DESIGN REVIEW COMMITTEE STAFF REPORT

2480 BANCROFT WAY FINAL DESIGN REVIEW

Design Review #DRCF2023-0005 to demolish a one-story retail building and construct an eight-story (95 feet) mixed-use building with 2,066 square feet of commercial area and 28 dwelling units including two Very Low-Income Units.

1 NORTH ELEVATION
A201 1/8" = 1'-0"

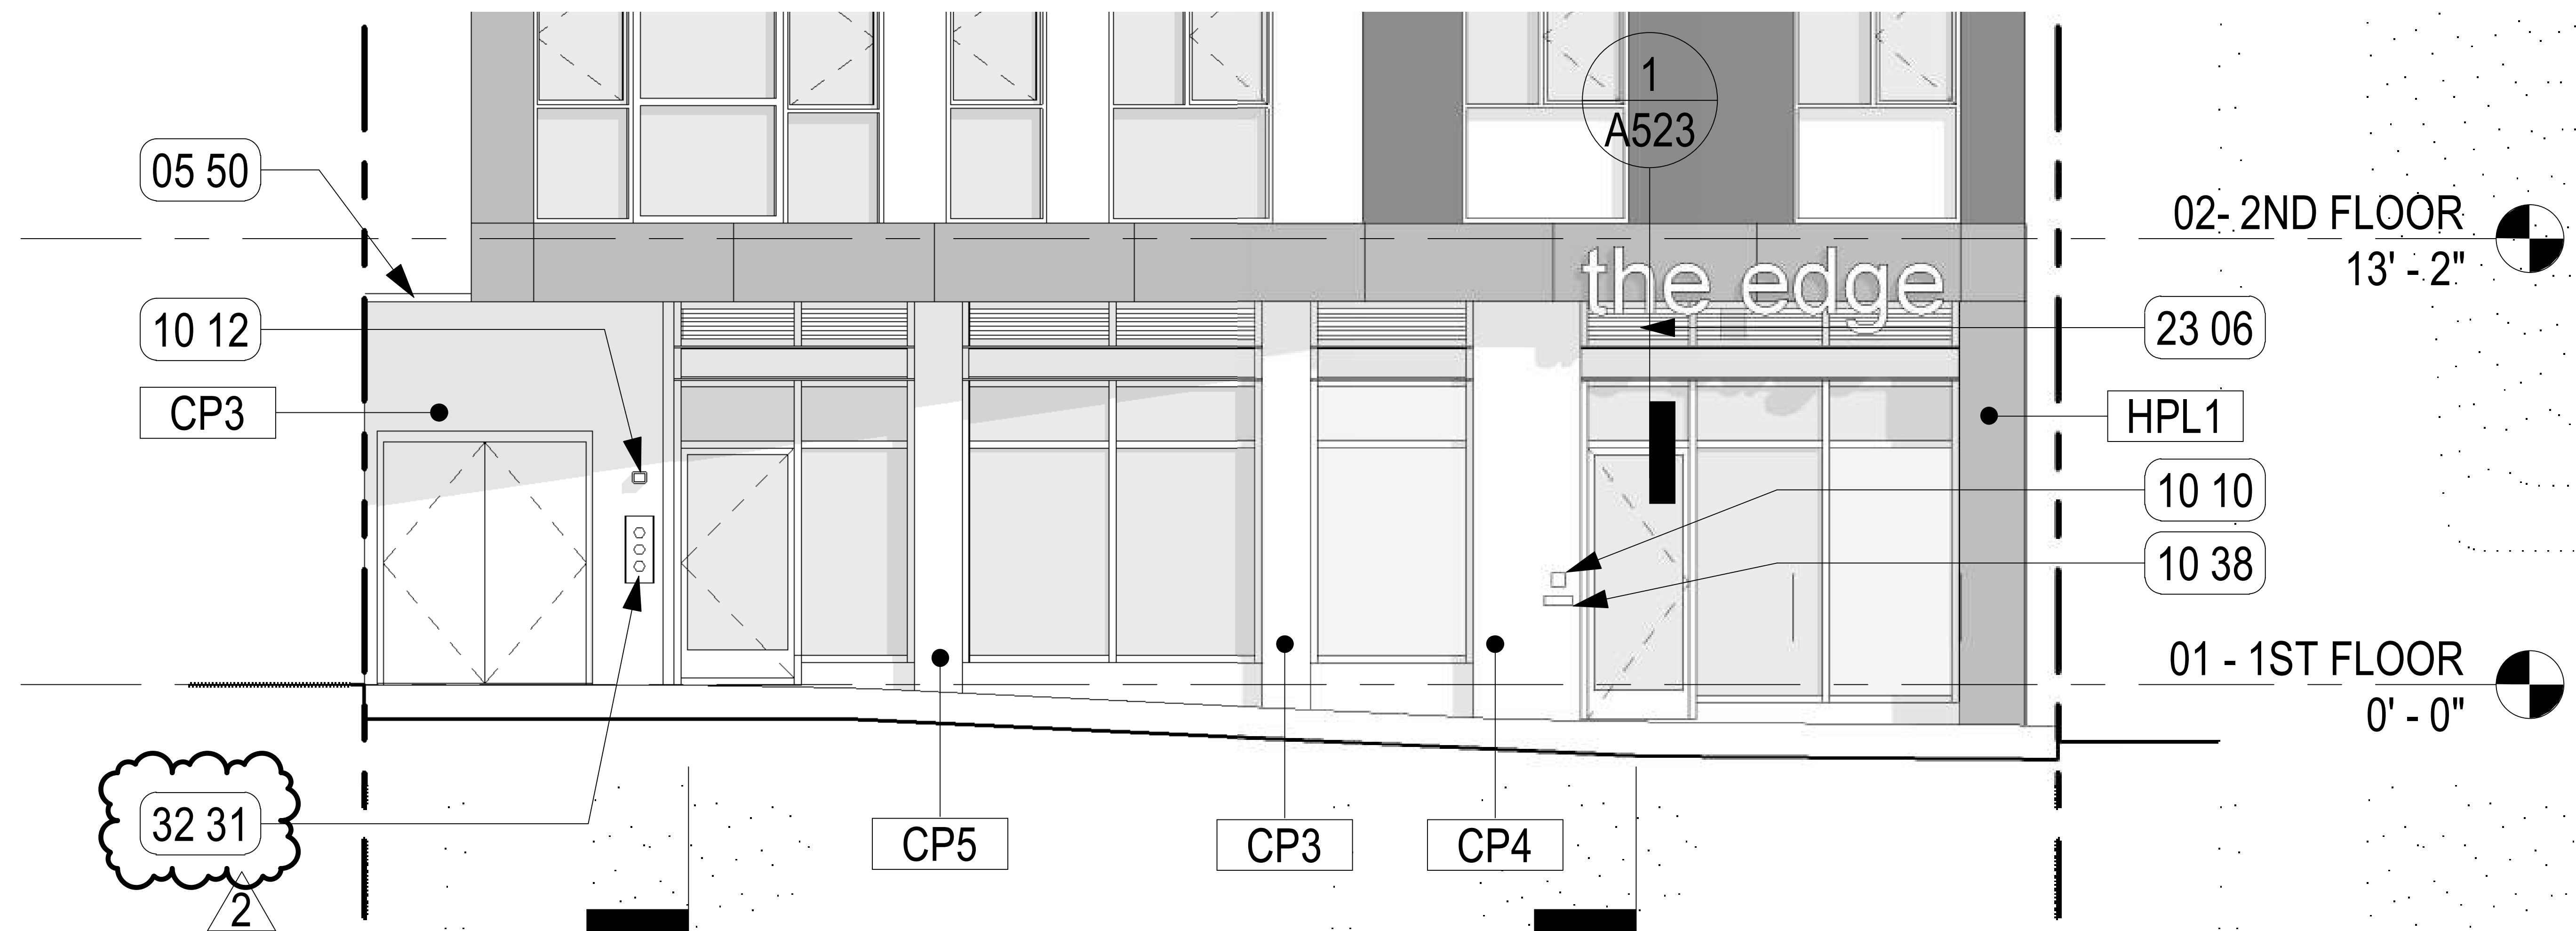
- *Ground floor looks too stark.*
 - **Front Facade Elevation & Enlarged Elevation**
- *Develop more pedestrian-friendly details at the base; provide better delineation of lobby and commercial entries.*

- *Consider more detail – such as special glazing treatment on the 2nd level - to add emphasis.*
 - **Per recommendation of the DRC we created a large window unit at the east end of the 2nd floor which mirrors in dimension the openings at the 4th and 6th floors.**

- *Consider bringing vertical accents down to the 2nd floor.*
 - **A vertical accent panel was added in the middle of the 2nd floor band, mirroring floors above.**

- **Planters were considered, however it was ultimately decided that due to the high pedestrian traffic they wouldn't likely survive and end up being a detractor rather than an addition to the storefront facade.**

- A consistent header and storefront treatment previously didn't provide visual distinction between restaurant and residential. We have provided vertical accents that tie the ground floor to the levels above and also serve to break up the header above - providing a significant delineation between the two uses.**
